Title: STAGE 2 ROAD SAFETY AUDIT

**Proposed Self Storage Warehousing Facility at Liffey Valley,
Lucan, Dublin 22.**

Report reference: 2107R01

VERSION: FINAL (19-12-2023)

Drawing USLV-GDE-ZZ-DR-C-0006 Rev T, GDCL, Motor Hall Road.

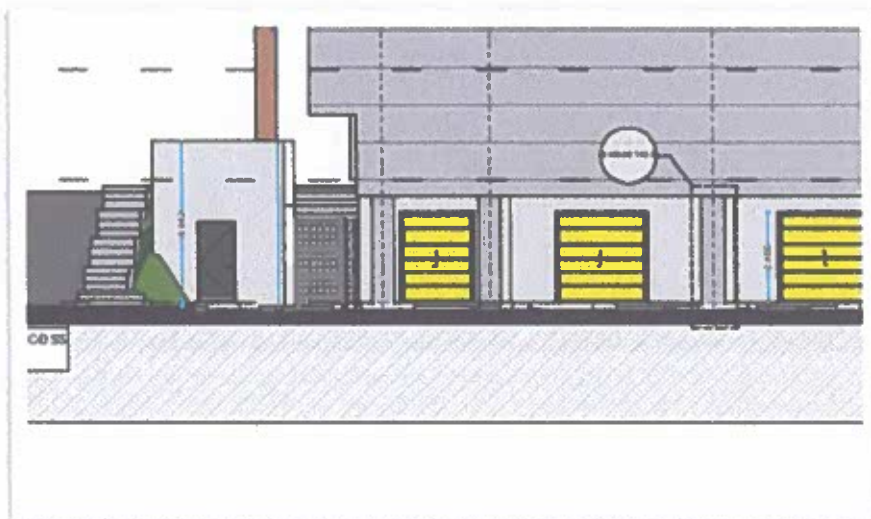
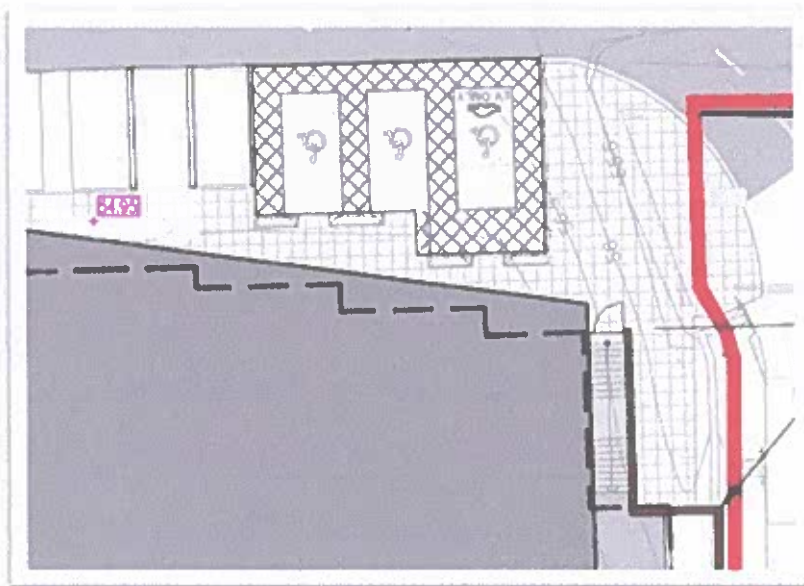
The new access to the development off Motor Hall Road is at the existing uncontrolled pedestrian crossing which is strategically located to serve the bus stops/laybys. A lack of crossing facilities could lead to trips on the high kerbs and interaction between turning vehicles and pedestrians.

It is recommended that a new crossing be provided for pedestrians.

Paragraph No. in Safety Audit Report	Problem accepted (yes/no)	Recommended measure accepted (yes/no)	Alternative measures (describe)	Alternative measures accepted by Auditors (Yes/No)
3.1	Yes	Yes New pedestrian Crossing shown		
3.2	Yes	Yes .Full disabled access is possible via Lifts at Basement Level .		
3.3	Yes	Yes		
3.4	Yes	Yes		
3.5	Yes	Yes		
3.6	No	No	This area has not been designed to accommodate HGVs , it is not anticipated they will use the area at all. Area limited to Vans/Small trucks.	Yes

Drawing USLV-GDE-ZZ-DR-C-0006 Rev T, GDCL, Disabled parking spaces.

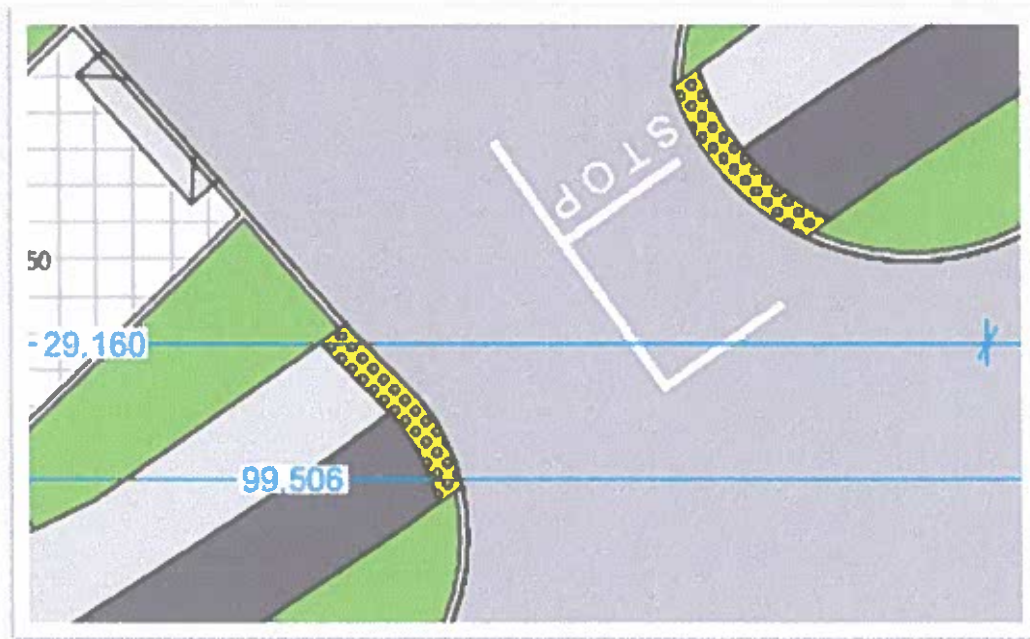
It is unclear if the mobility impaired using the disabled parking spaces to the rear of the building will be able to access the building from the spaces without having to travel up steps. A lack of facilities for the mobility impaired could lead to falls or inaccessibility.

Ensure all parts of the building can be accessed by disabled users of the rear parking spaces.

Drawing USLV-CKA-401 Rev -, Carew Kelly Architects, New access.

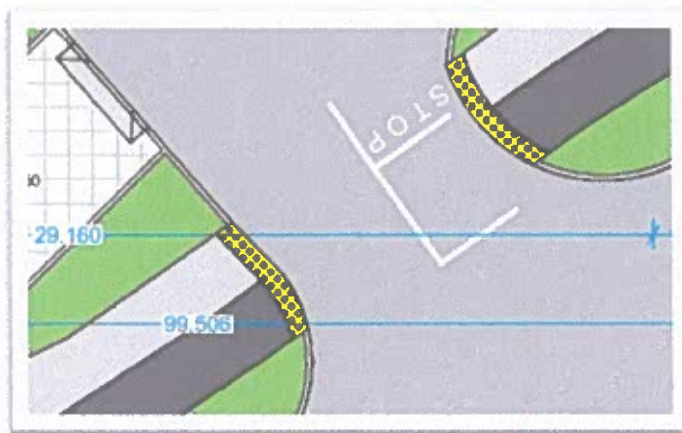
Some tactile paving is shown at the new access where the cycle track and footpath are intersected. The proposed depth of the tactile paving is unclear. The crossing is an in-line crossing and if the tactile paving is not deep enough then blind or partially sighted pedestrians may not detect it under foot which could result in collisions with turning vehicles.

It is recommended that a suitable depth of tactile paving be provided for an inline crossing. Suitable depth dropped kerbs should also be used to avoid trip hazards and not prevent accessibility.

USLV-GDE-ZZ-DR-C-0004 Rev T, GDCL, Motor Hall Road, Drainage.

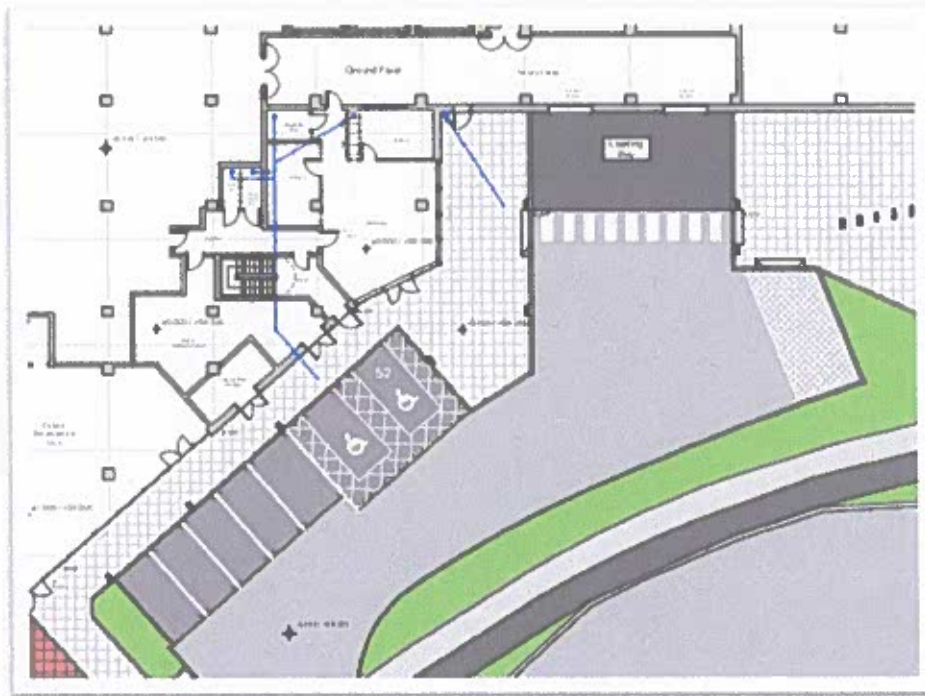
There is a risk of surface water ponding at the dropped kerbs of the new access which could lead to slips and falls for pedestrians and loss of traction and loss of control for cyclists.

It is recommended that gullies be provided immediately upstream of the dropped kerbs
